ADDENDUM NO. 7

HVAC & CONTROLS REPLACEMENT/ADDITION AT NINE (9) SITES: BARRANCA, BEN LOMOND, CYPRESS, GROVECENTER, MANZANITA, MERWIN, MESA, ROWLAND, AND WORKMAN ELEMENTARY SCHOOLS RFQ/RFP #22-23-105

January 19, 2023

BUILDING F MECHANICAL FLOOR PLAN
SCALE: 1/8" = 1'-0"

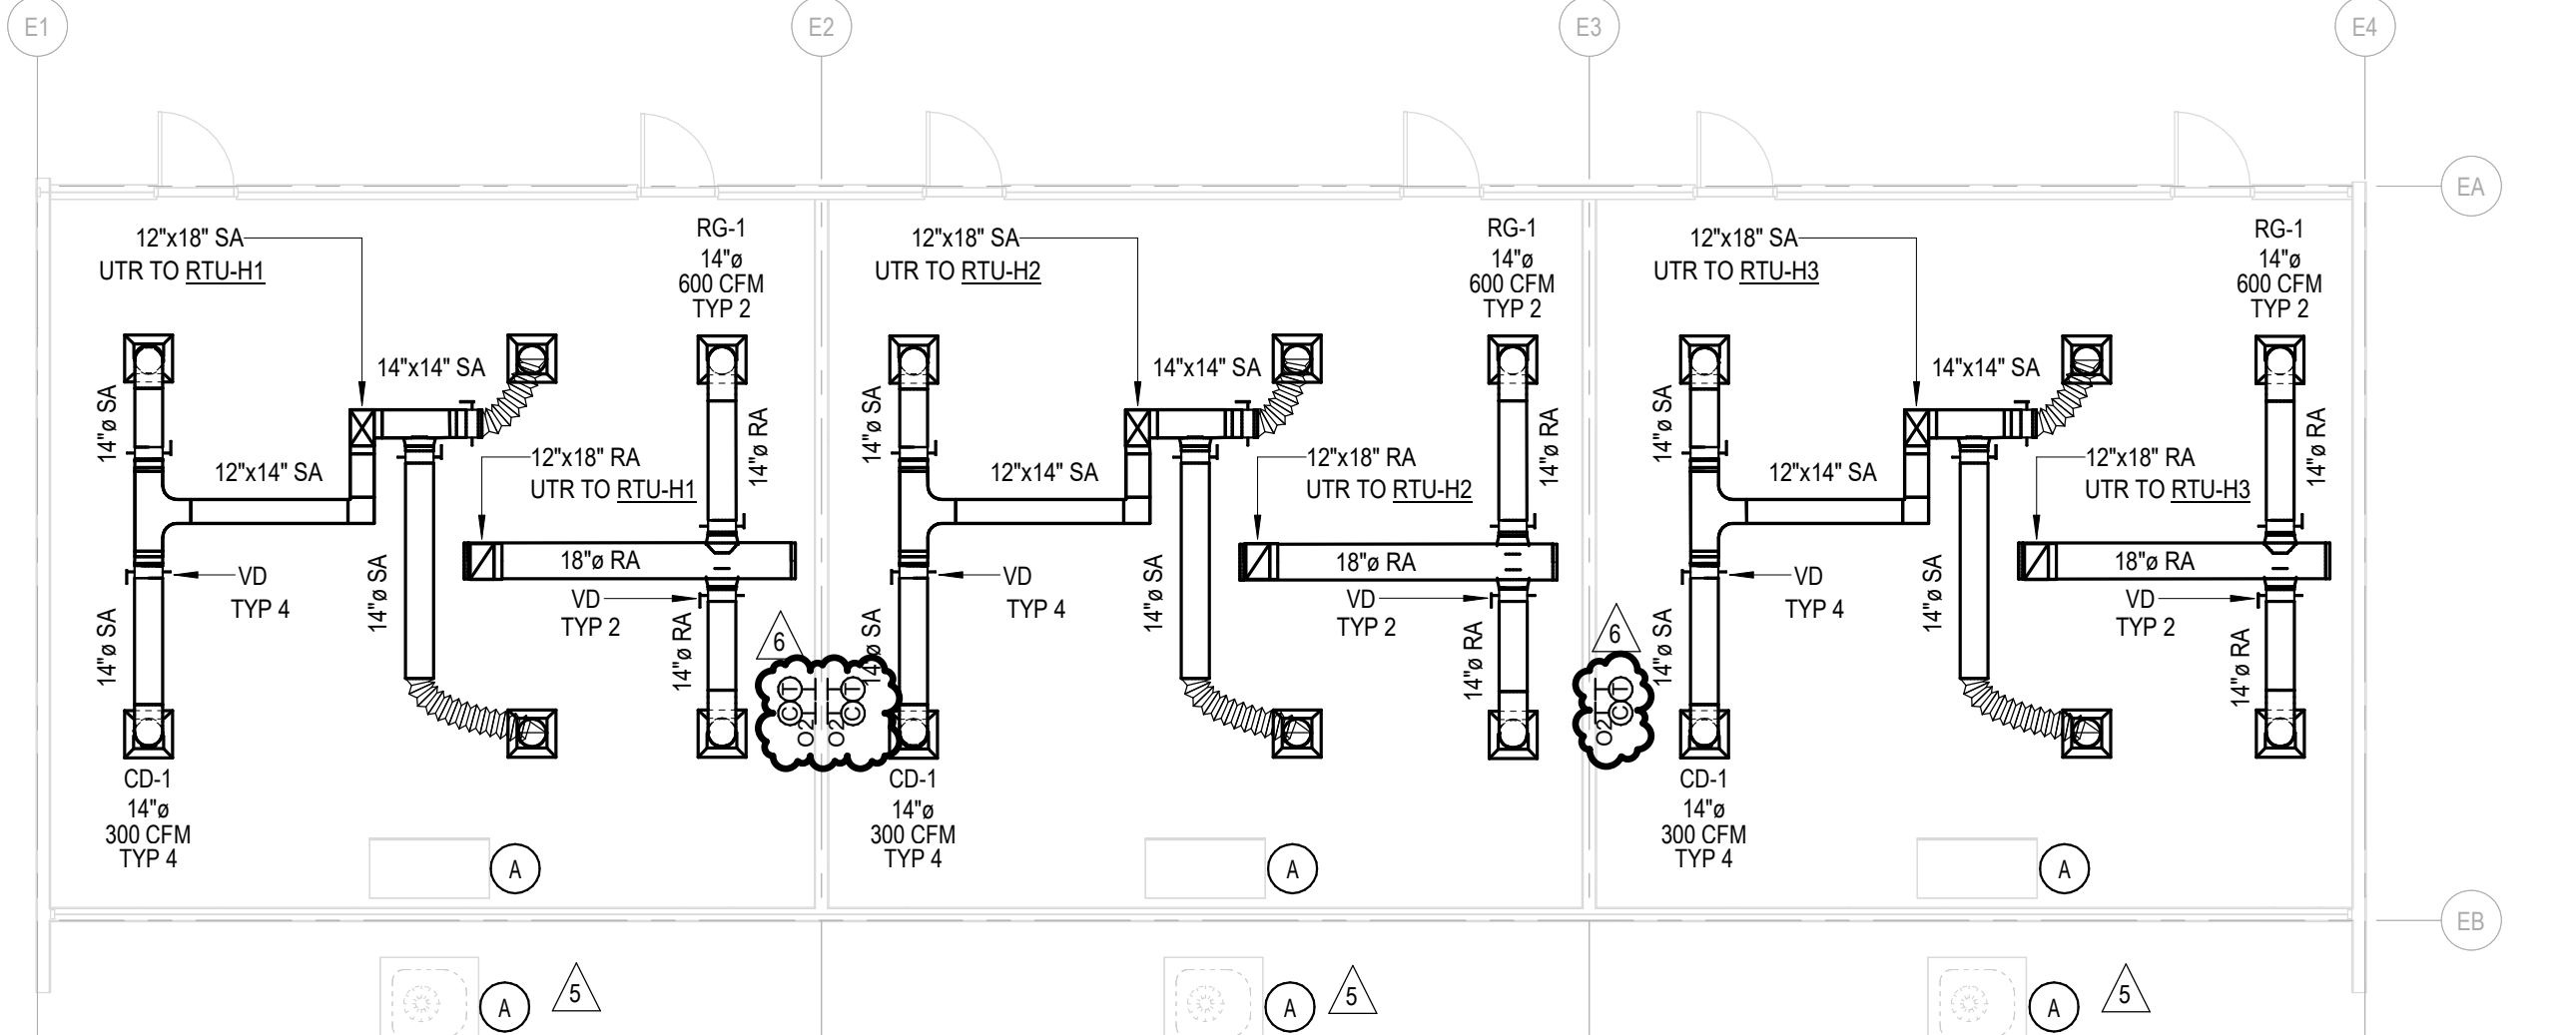
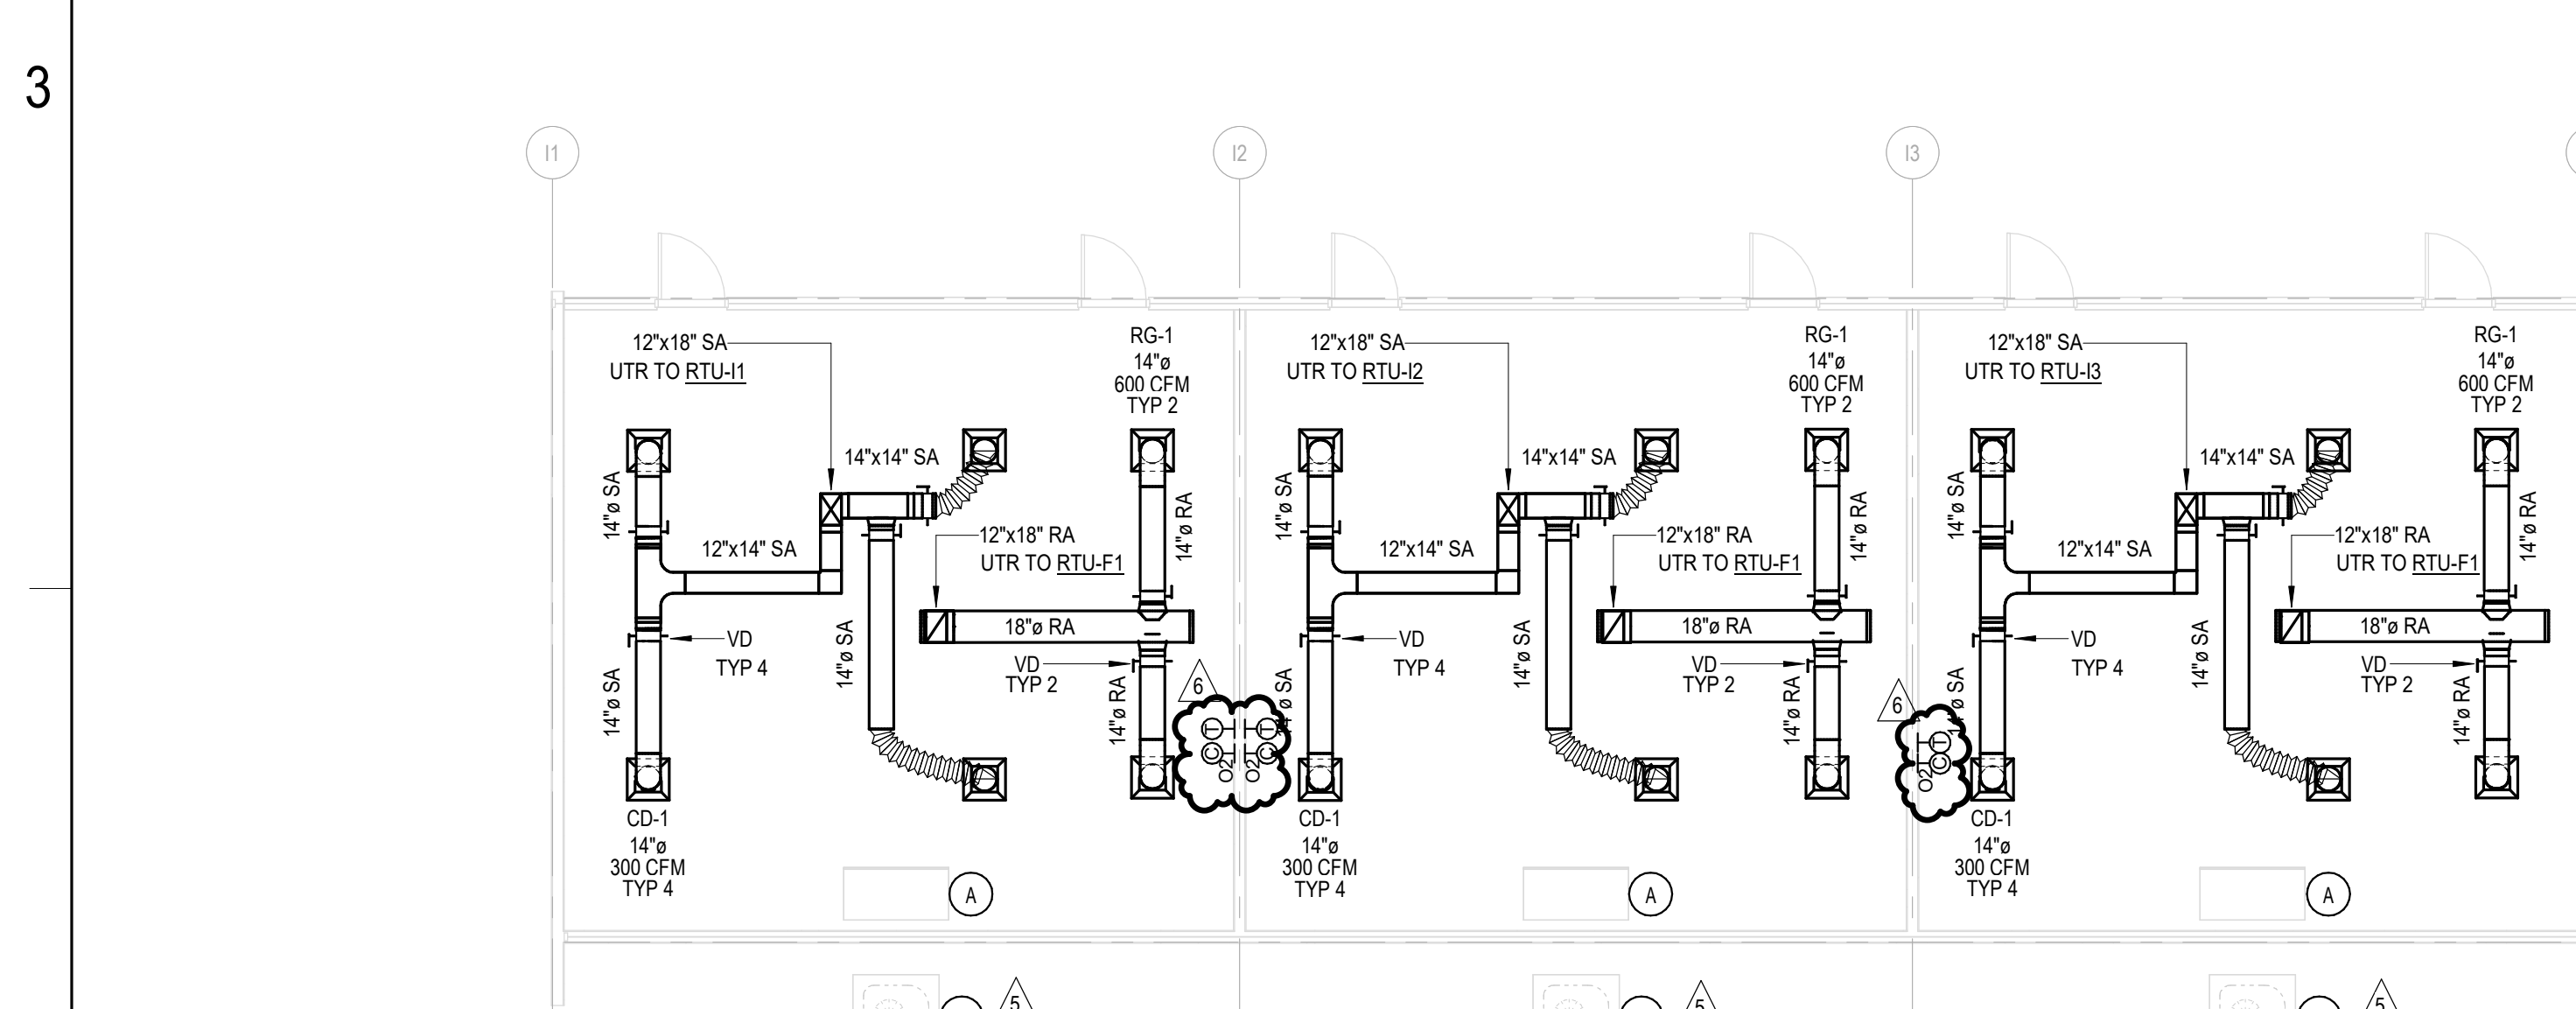
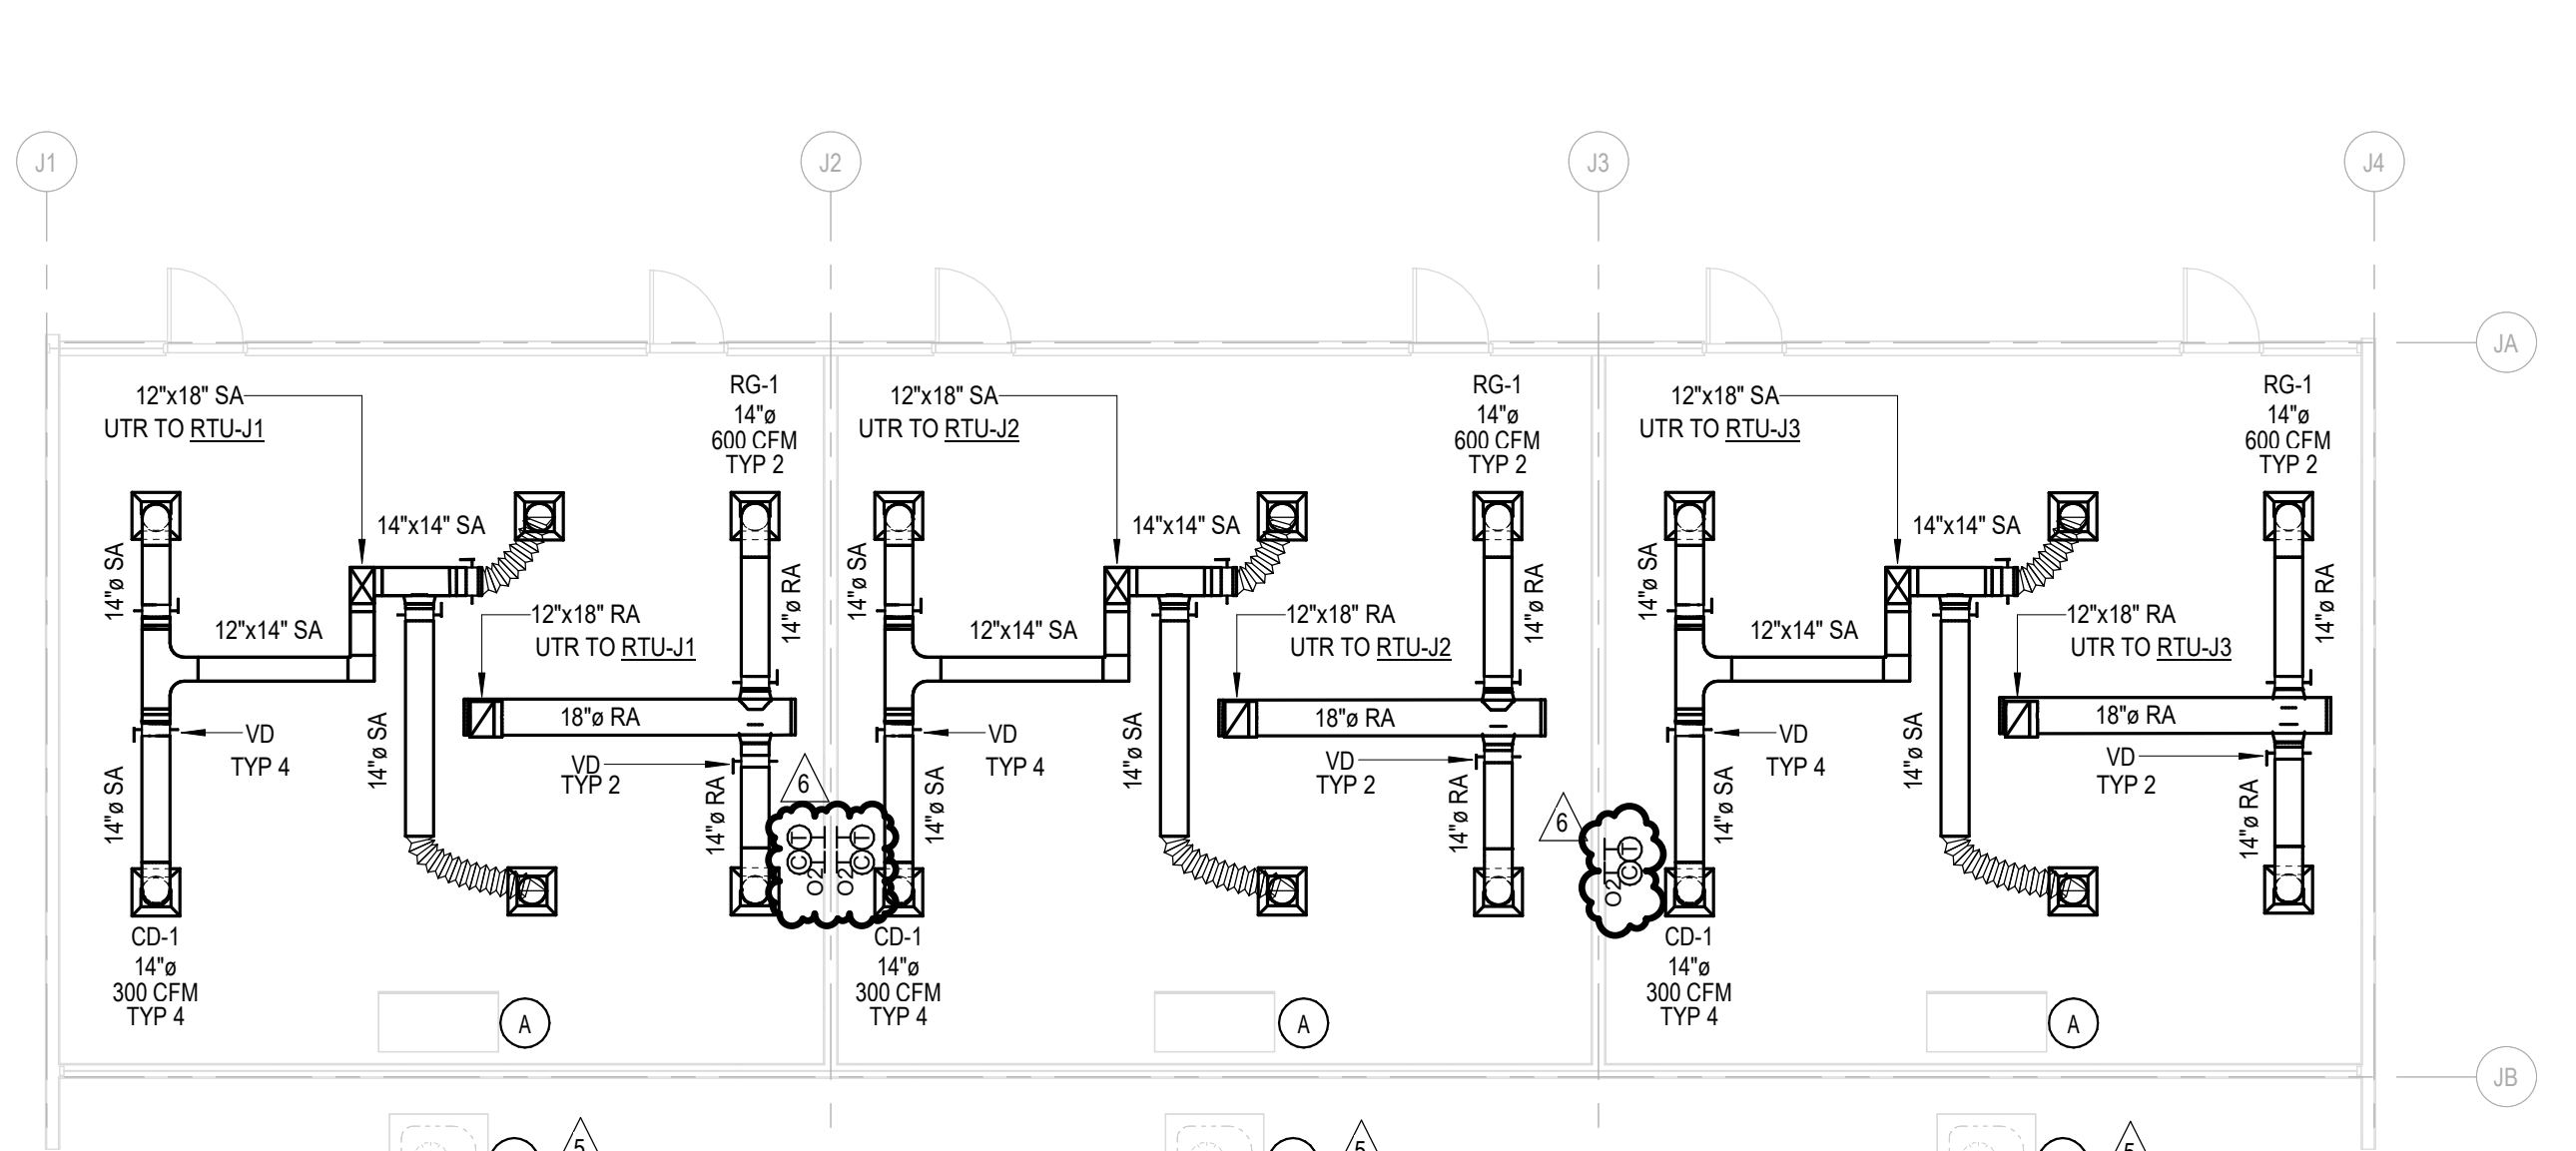
(Page M1.1A)

-Building H: RTU-H2 There is T stat locations on both walls on GL E2 and E3. Please confirm what wall the sensor is to be located.

DLR Response: See attached updated drawing M1.1A. Also, CO2 sensors are added in each classrooms same as the other schools.
